UNITED STATES PATENT AND TRADEMARK OFFICE

10/562,640

<i>Office Action Summary</i>	Application No.	Applicant(s)	
	10/562,640	JAMES ET AL.	
	Examiner	Art Unit	
	JUSTIN KRAUSE	3656

DETAILED ACTION

FIG. 2

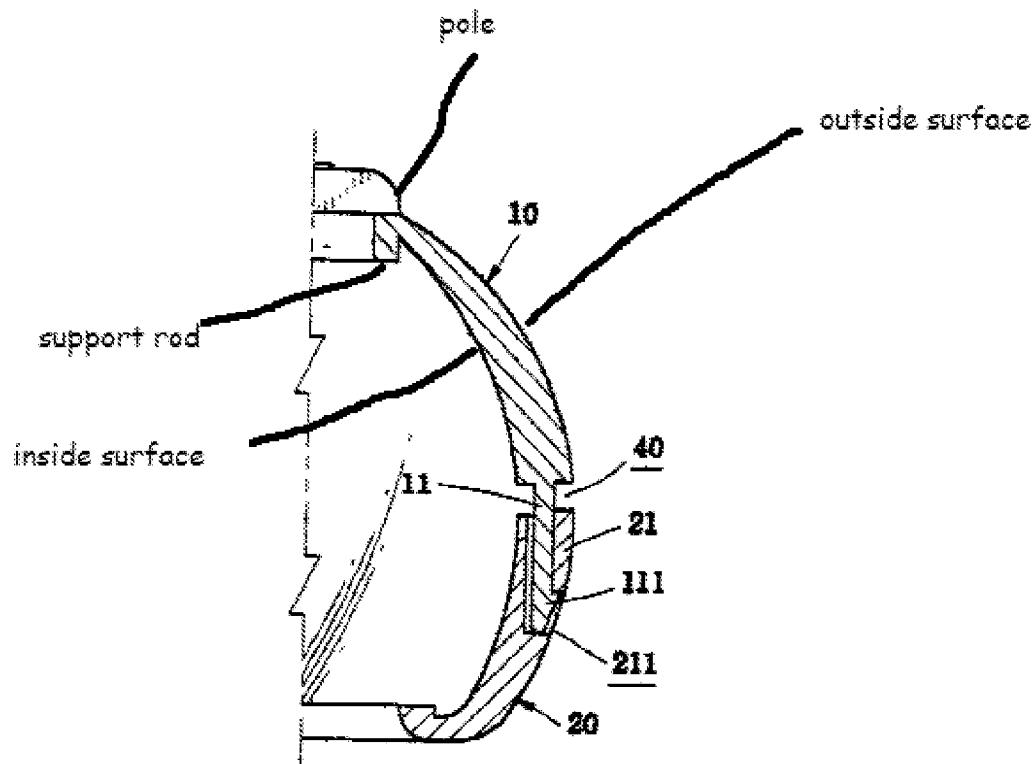
Chuang discloses a resonator comprising a shell (10) having a pole (top of shell) held by a support rod , the shell having an annular edge (the bottom, horizontal surface of the shell, generally 40) defined by an inside surface and an outside surface (see fig. 2, for example) that are substantially hemispheres and that extend around a common axis of revolution, wherein a center of the inside surface and a center of the outside surface are offset relative along the axis of revolution to each other with a predetermined distance between the centers and a radius of the inside surface is different from the radius of the outside surface in such a manner that the shell presents a thickness along the annular edge that is greater than the thickness that the presents in the vicinity of the pole (fig. 2).

Regarding claim 4, the centers of the inside and outside surfaces of the shell extend on either side of a plane containing the annular edge.
